## MEMORANDUM

<b>To:</b>	Ray Hiemstra and Mandy Sackett
<b>From:</b>	David Revell, PhD
<b>Date:</b>	4/27/2021
<b>Subject:</b>	Response to Poseidon's comment letter from 2/4/2019
<b>Project No.:</b>	C3010

Figure 1. Model results showing existing groundwater levels of 1 to 2 meters is most consistent with available groundwater monitoring data described in Report.

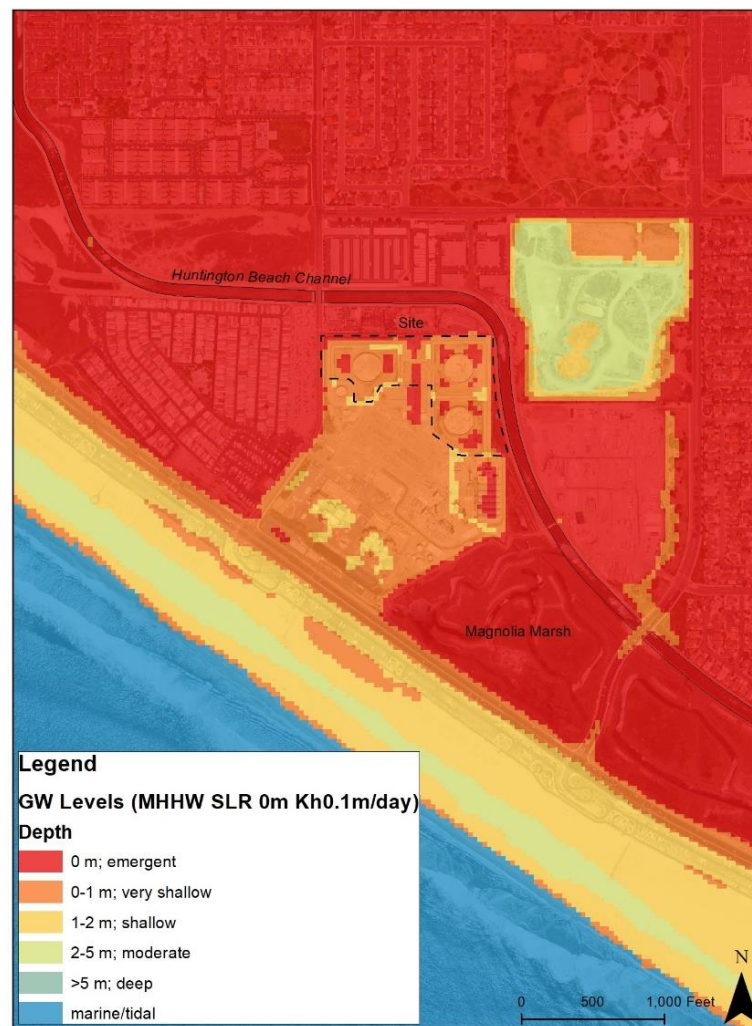
The Report reviewed available groundwater information and identified that a shallow near surface groundwater condition with average depths from 5 to 9 feet presently exist and vary based on tidal influence and seasonality.<sup>17</sup> The Report raised concerns about groundwater daylighting as sea level rises as well as potential for liquefaction during an earthquake that was beyond the scope of the study but worthy of additional examination.

In August of 2020, the USGS released results of a new study “Projected responses of the coastal water table for California using present-day and future sea-level rise scenarios” (Befus et al 2020). This study applied a widely accepted groundwater model (MODFLOW) with various assumption on hydraulic connectivity or the sediments and sea level rise scenarios to examine the groundwater depth and the potential for groundwater daylighting. The depths were calculated based on existing topography. Comparing the model results with monitoring data shows that a horizontal hydraulic conductivity of 0.1 Kh best matches existing monitoring data referenced in the Report (Figure 1).

Figure 2. Groundwater conditions modeled with 3.3 feet of sea level rise (left) and 6.6 feet of sea level rise (right).

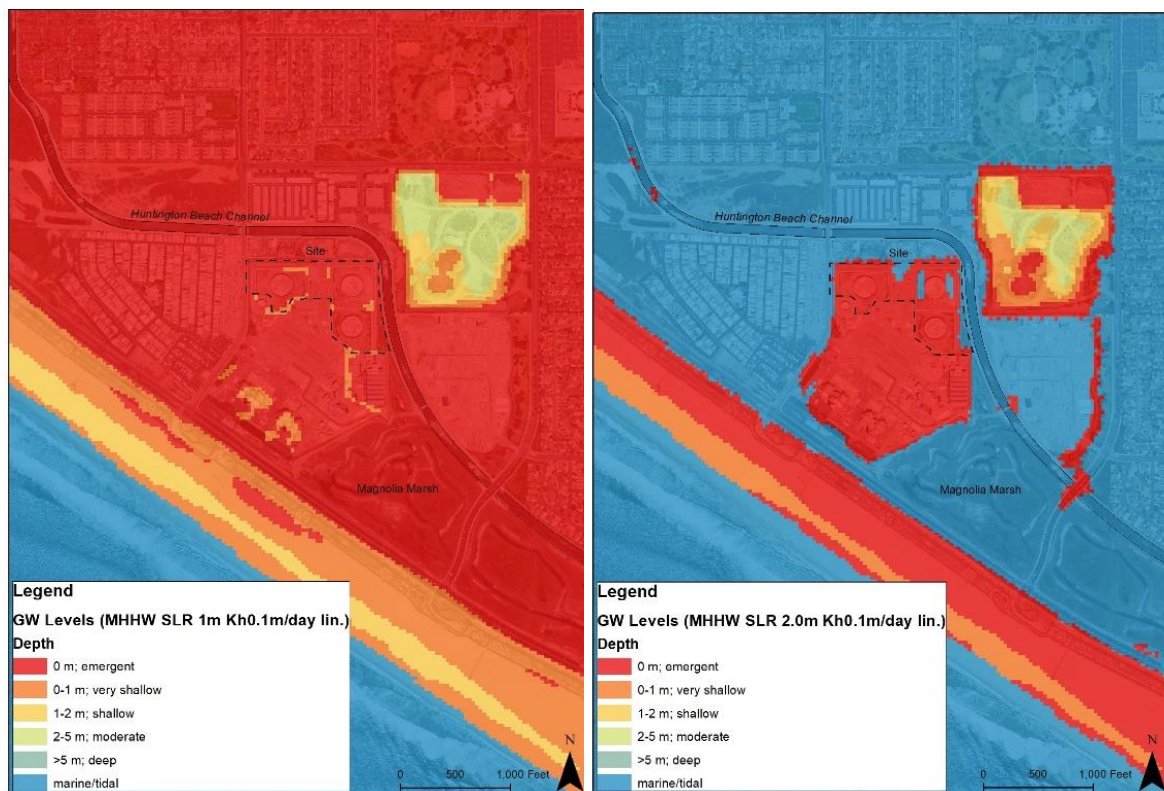
Using that best model fit verification of hydraulic connectivity and adding 3.3 feet (~2050, 1m) and 6.6 feet (~ 2080, 2m) of sea level rise, groundwater levels at the site are shown in Figure 2. Note that the 3.3 foot projection is closest to being consistent with the OPC Strategic Plan used for planning purposes.

These results show that with 3.3 feet of sea level rise most of the site could have groundwater at or very near the surface, and during high king tides or other high water events, likely daylighting on the site. With 6.6 feet of sea level rise, the site becomes a man-made island surrounded by a manmade berm with periodic groundwater daylighting on the facility. The entire access to the site would likely be underwater during daily high tides. While Integral acknowledges that the groundwater depths were calculated based on existing topography and not the future finished grade (assumed to be 14ft NAVD). Despite that, areas outside of any elevated grade as well as access to the site will be affected.

These new groundwater results also raise concerns that with increased groundwater elevations may also come more rapid deterioration and increased buoyancy forces on all of the transmission pipelines critical to serving the proposed water supply.

Additional work is likely required to evaluate the potential cumulative impacts of elevated groundwater on the proposed project, transmission pipeline infrastructure, and adjacent sites.
